5101Permit1994 - Batch No. _____

Re: Johnston County Landfill Site Study

Subtitle D Landfill Site Application Report for Proposed Expansion of the Johnston County Landfill, Johnston County County, North Carolina, Final Revision December 1994. Submitted by McKim and Creed Engineers, P.A.

Re: General Conditions and Site Specific Design Requirements for the Proposed Johnston County
Landfill Expansion,

TYPICAL MONITORING WELL SCHEMATIC

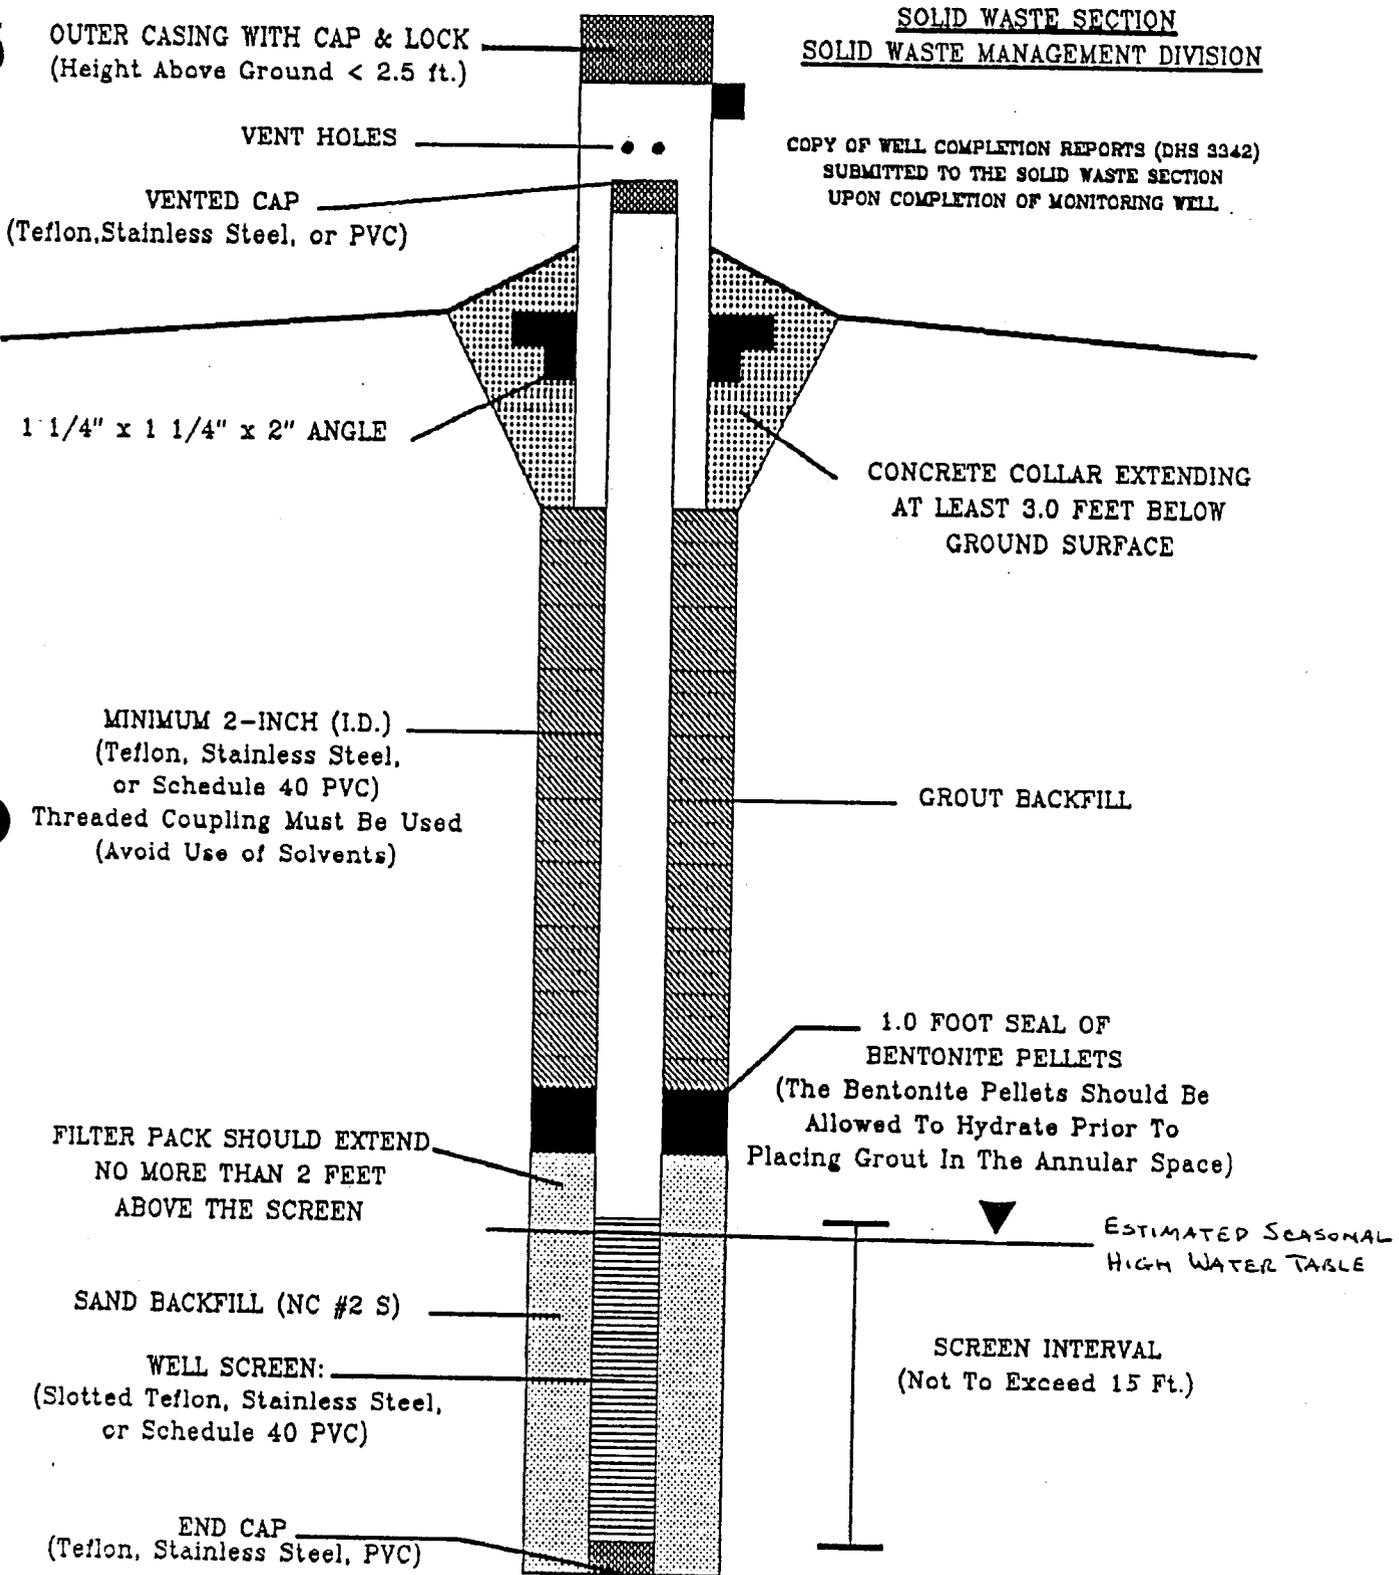
The monitoring wells are to be constructed according to the specifications in the "North Carolina Water Quality Monitoring Guidance Document For Solid Waste Facilities" as illustrated by the Typical Monitoring Well Schematic" diagram enclosed.

**Jo. Co.
LANDFILL
SCALE: 1" = 200'**

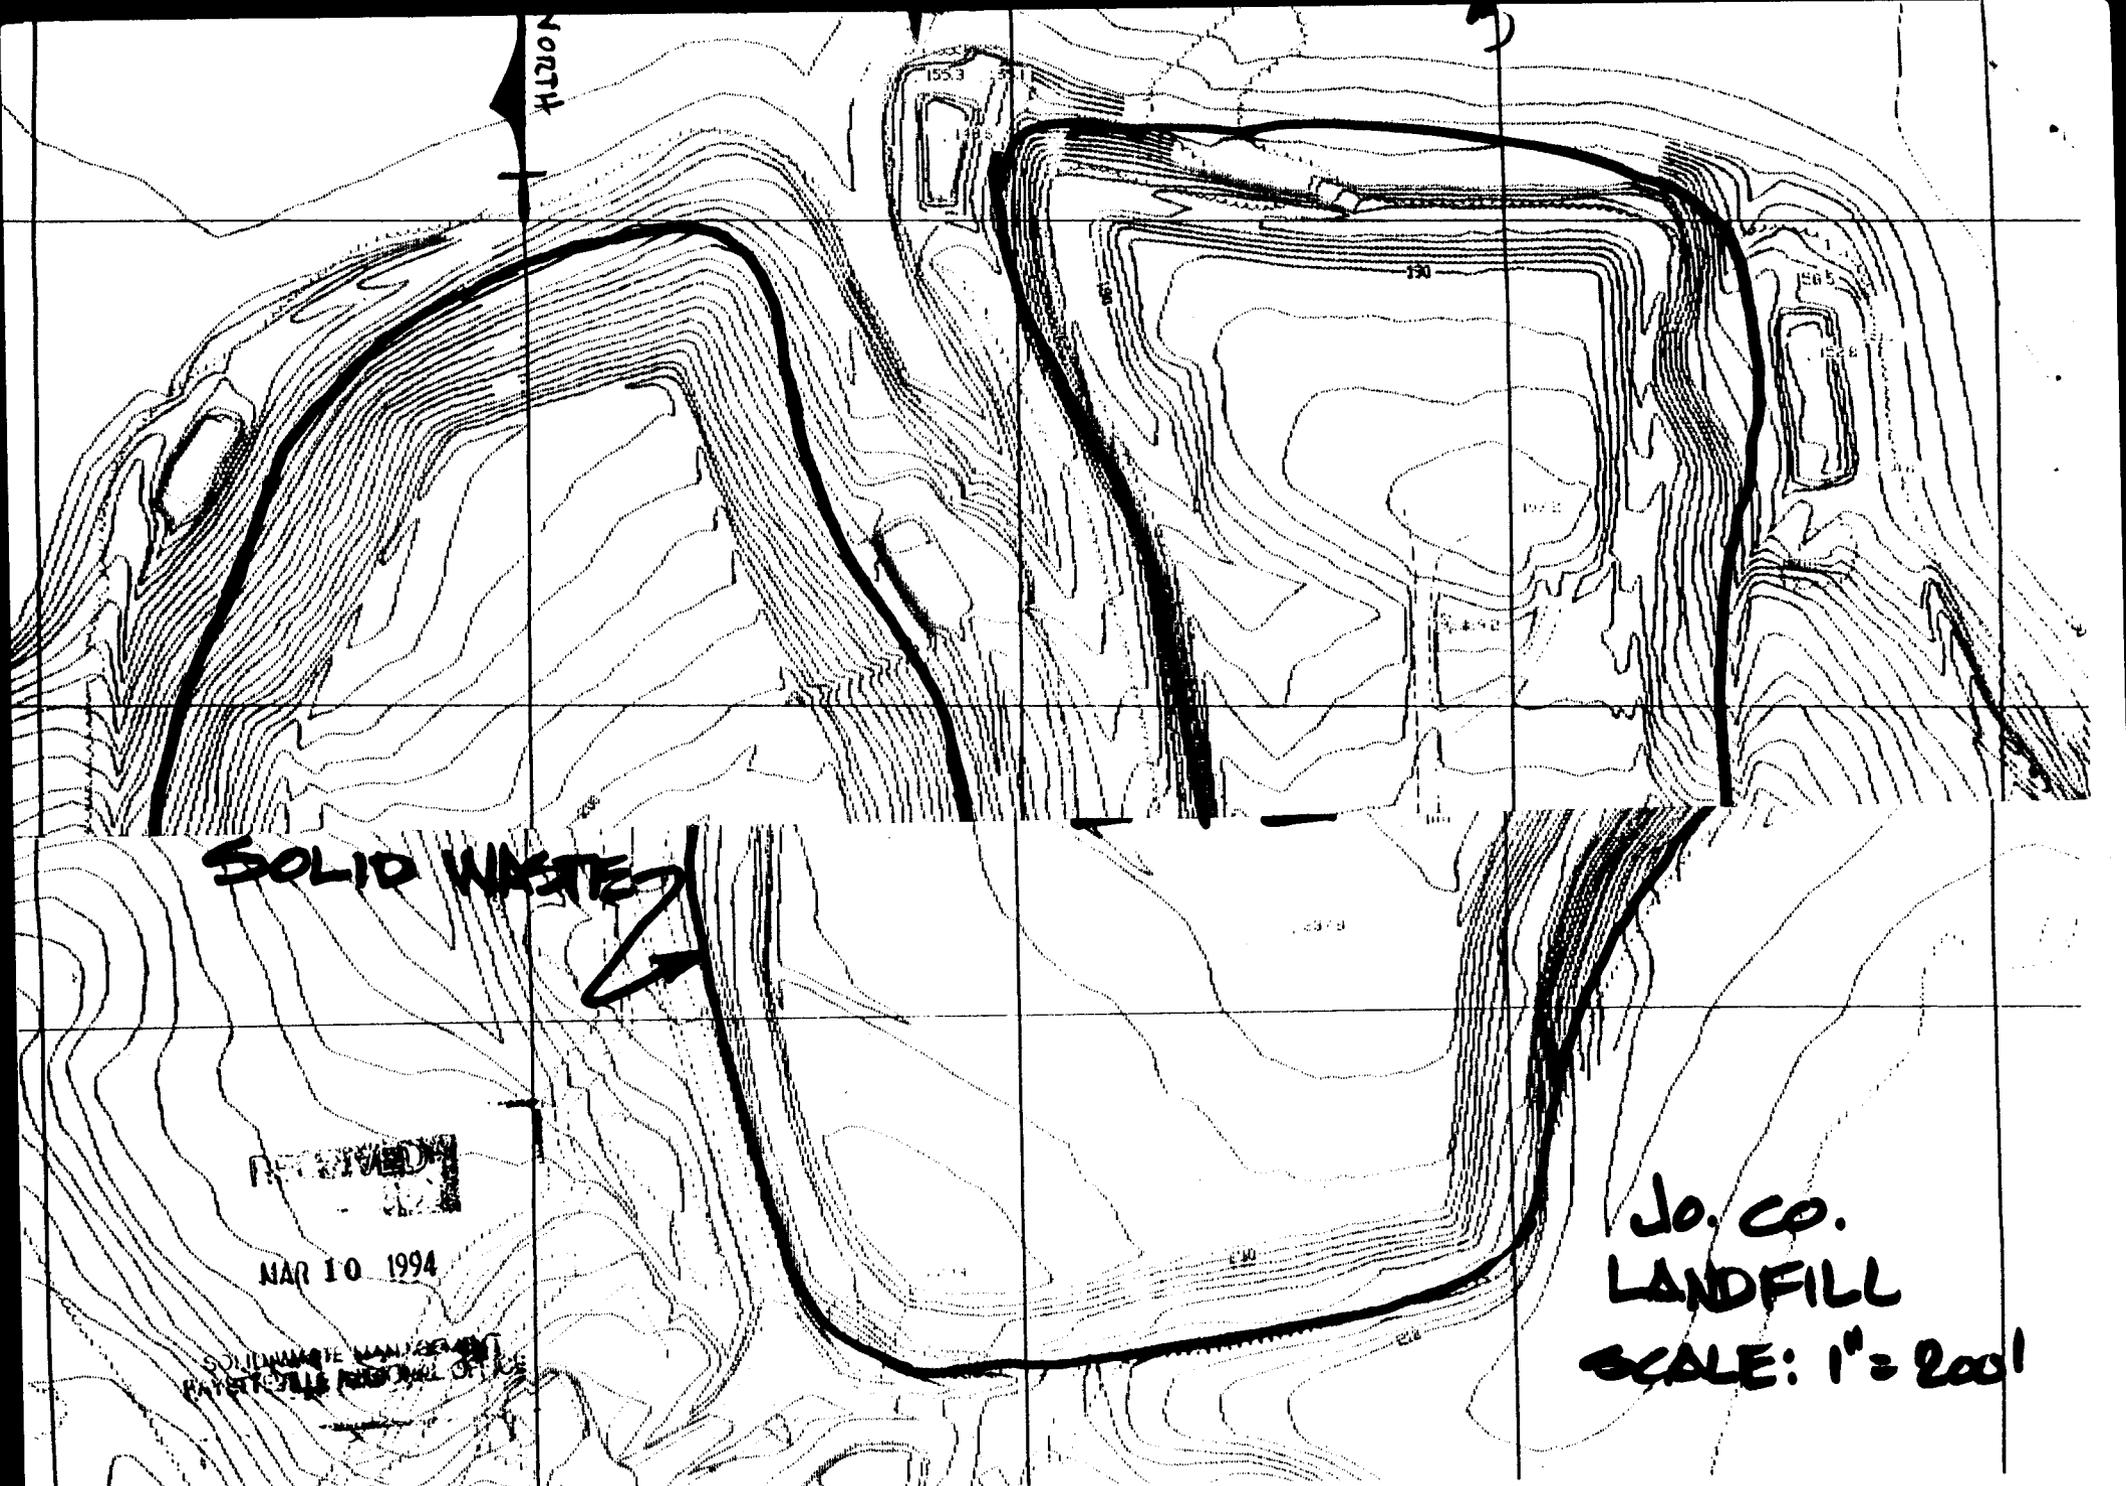
- A. The existing landfill has a leachate problem which will impact the Transition Plan. We are to submit a plan addressing this item to the Solid Waste Section as soon as possible and prior to submitting the Transition Plan. Also, due to this problem the expected life of the existing landfill will probably be limited to no more than 2-1/2 years under the Transition Plan, or until October 9, 1996..

- B. Due to the property boundary location and the leachate problem in Phase I and II no permitted life remains and we cannot place additional trash on top of this area, as shown on the attached sketch. Also due to the proximity of the leachate to the existing property line it was discussed that the owner should acquire additional buffer along Buzzard Branch.

- C. The County will continue to work in Phase III under the permitted vertical expansion. We will adjust the finished grade toward the south end to maintain a 5% min. slope on the top to meet the new regulations.

- D. In Phase IV, we can finish filling the southeast corner and adjust the finish grade in this area to meet the new slope requirements.
- E. We are to prepare the Transition Plan according to the above mentioned conclusions.
